## **ADDENDUM NO. 02**

BID St Louis Lambert Readiness Center-Upgrade Latrines & Showers,  
Building 233  
St. Louis, Missouri  
PROJECT NO.: T2417-01

St. Louis Lambert Readiness  
Center - Latrines and  
Shower Renovations,  
Building 233, T2417-01

AD101

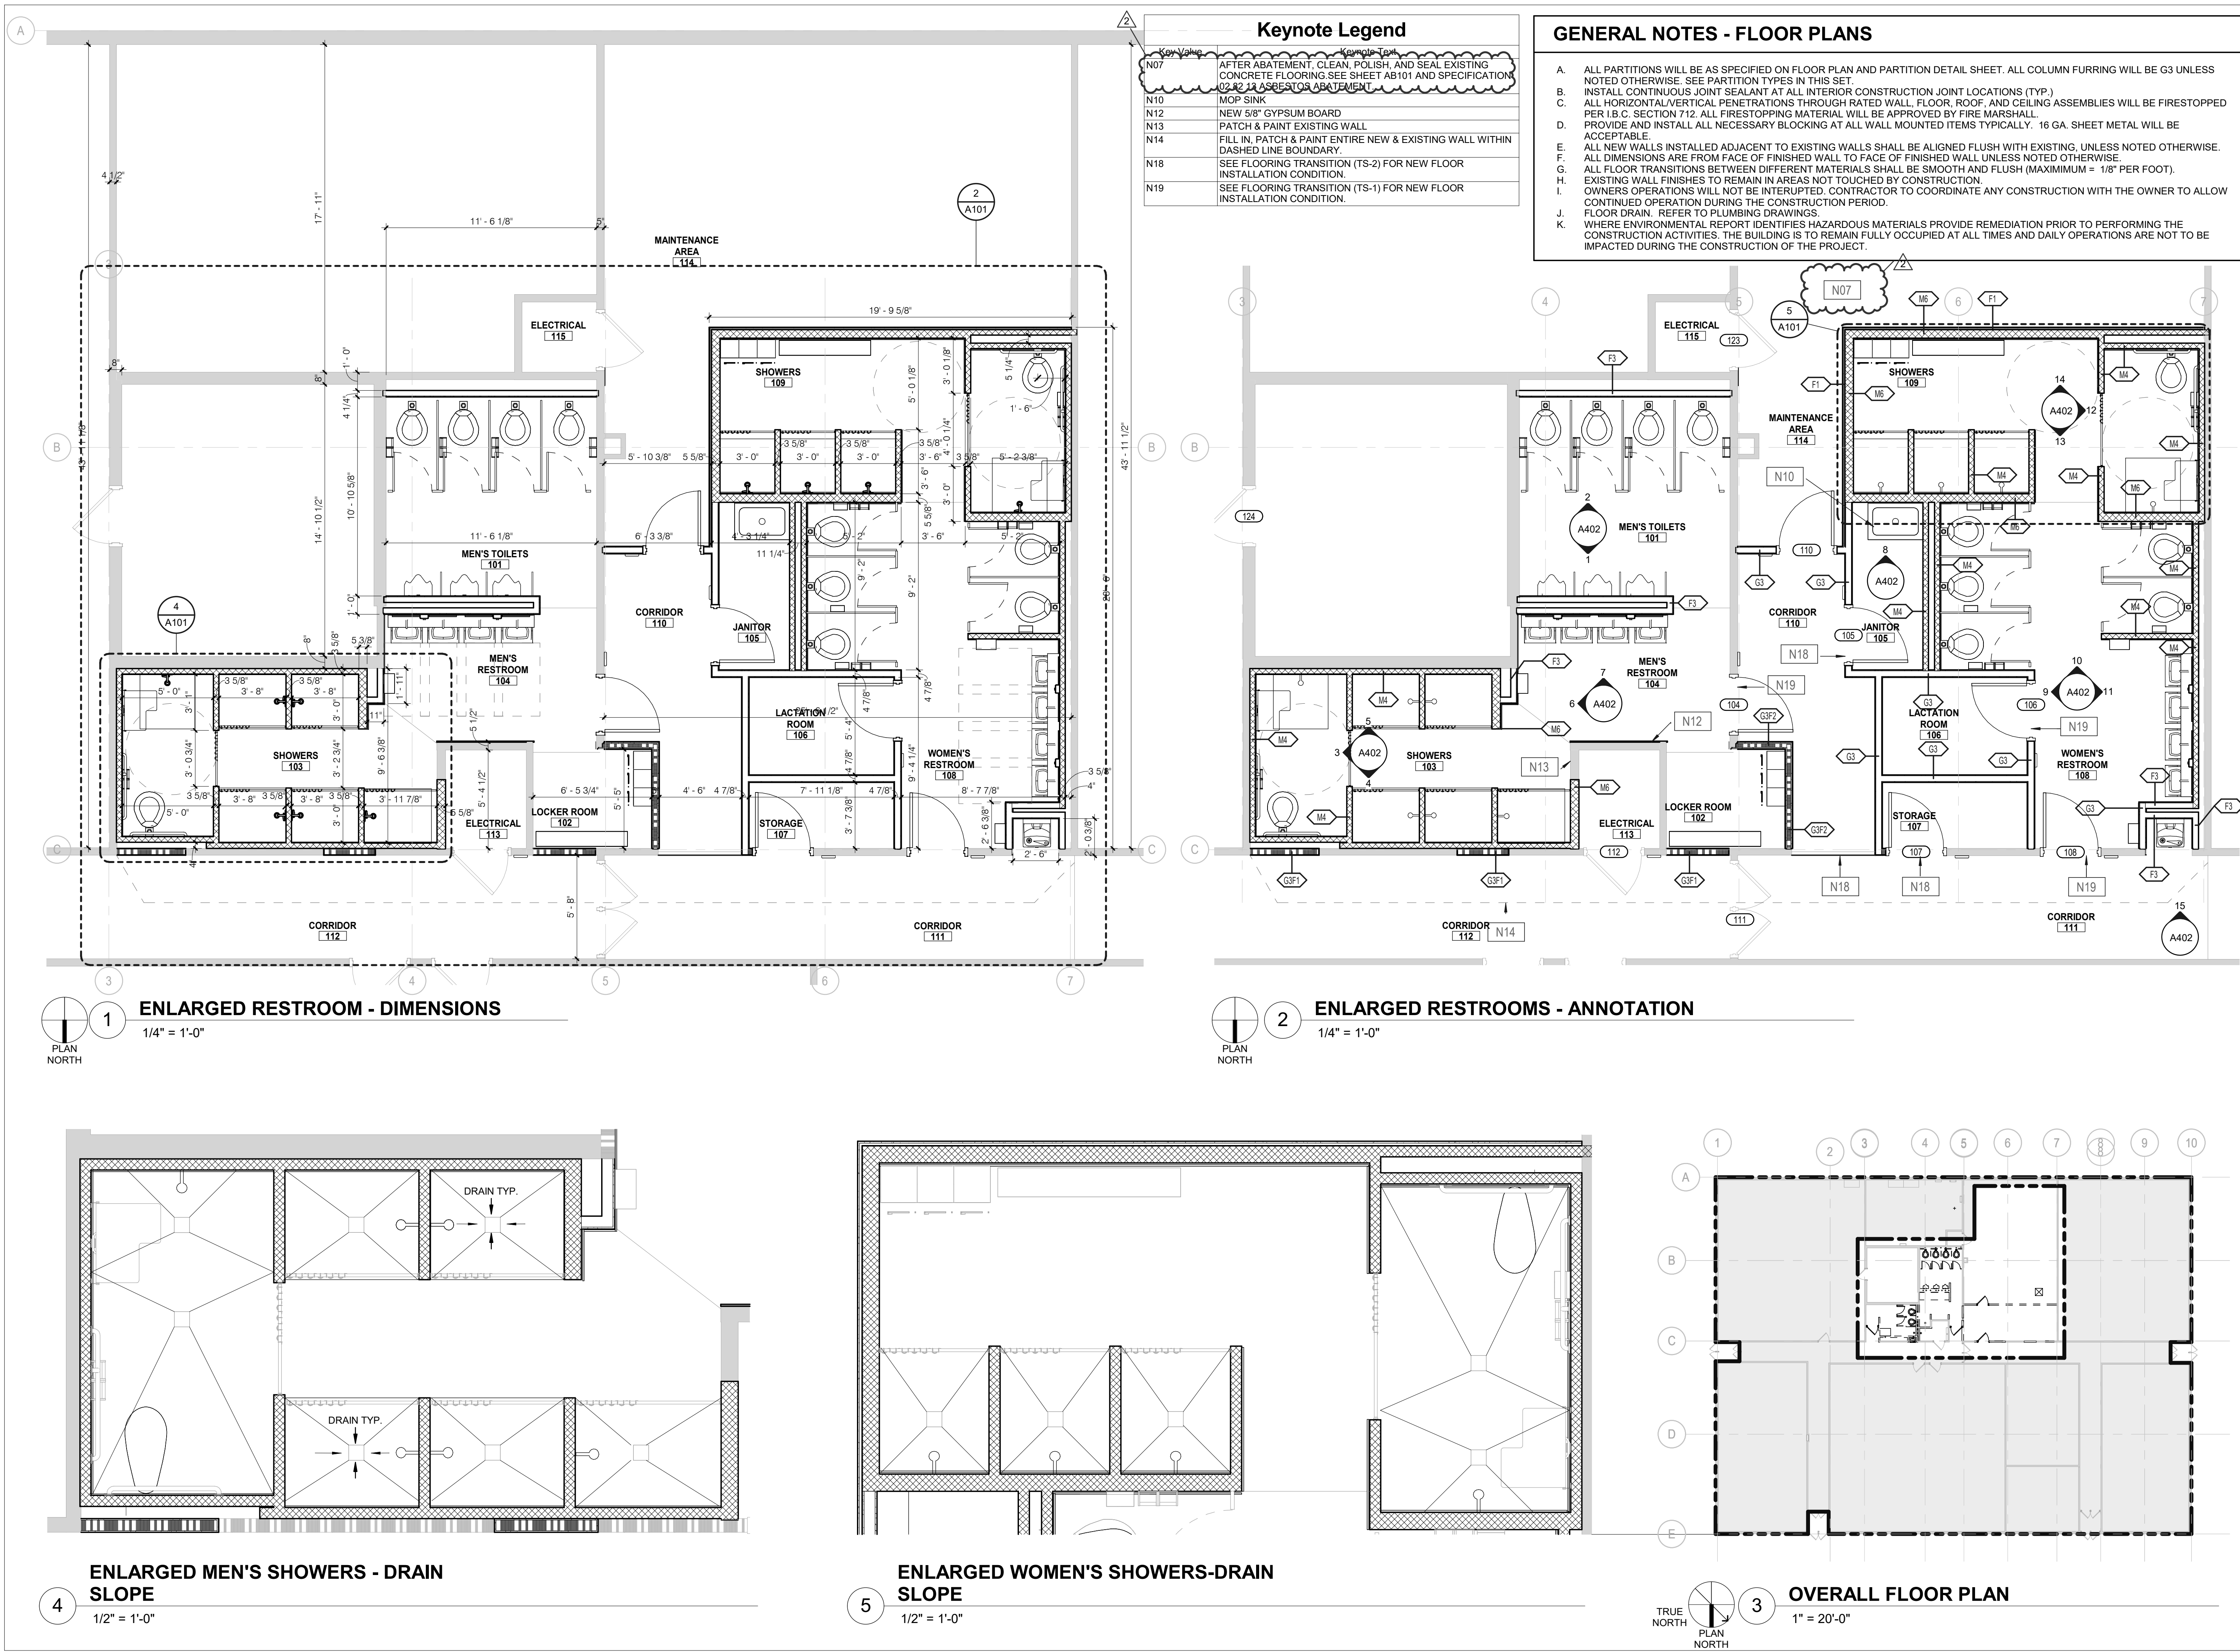
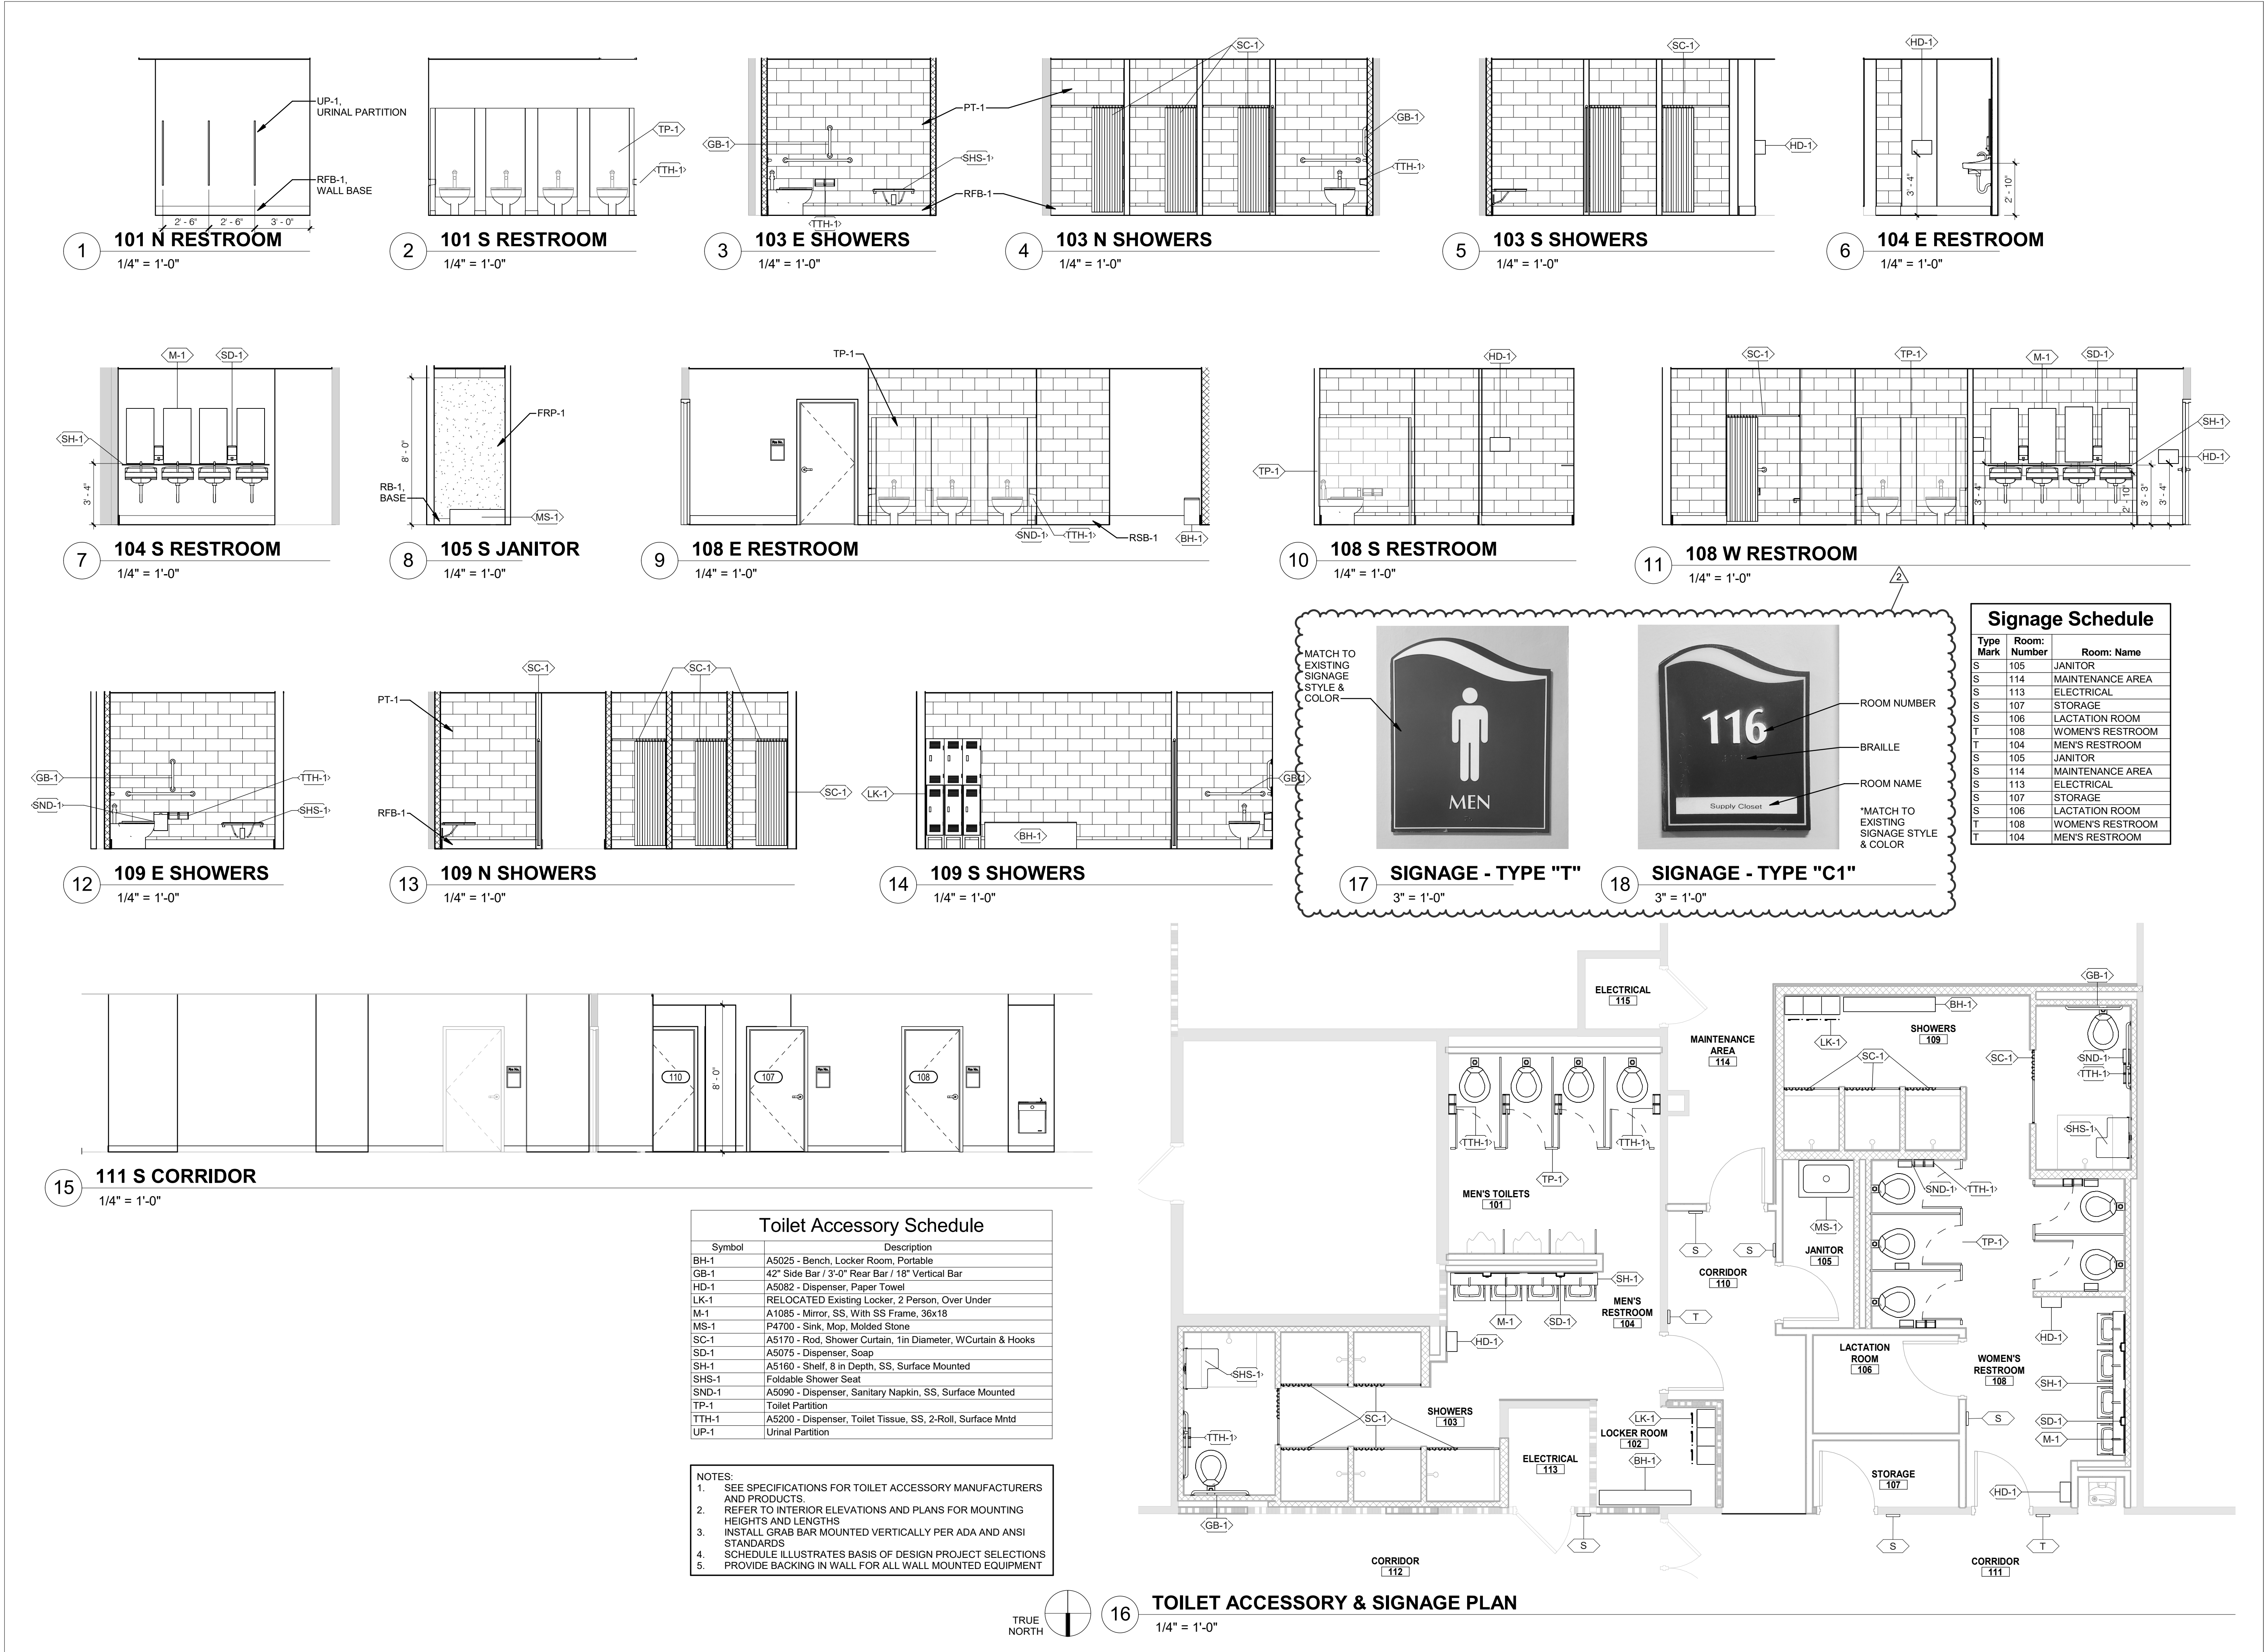
1. Sheet AD101
  - a. Updated Keynote D10
2. Sheet A101
  - a. Updated Keynote N7
3. Sheet A402
  - a. Updated details 17 and 18 to match existing signage.
4. Sheet A701
  - a. Resinous Flooring symbol is now shown as RSF-1 and Corresponds with the Room Finish Schedule.
5. Sheet AB101
  - a. ADD in its entirety

D07	REMOVE EXISTING METAL STUD WALL CONSTRUCTION AS REQUIRED FOR NEW DOOR OPENING. REFER TO THE ARCHITECTURAL DRAWINGS AND OPENING SCHEDULE FOR ADDITIONAL INFORMATION.
D09	COORDINATE WITH ANY IN FLOOR TRENCHING (P102). SEE ENVIRONMENTAL ITEMS IN ROOM 125.
D10	ABATE AND REMOVE EXISTING HAZARDOUS MATERIAL FLOORING. SEE SHEET AB101 AND SPECIFICATION 02.02.13 ASBESTOS ABATEMENT.
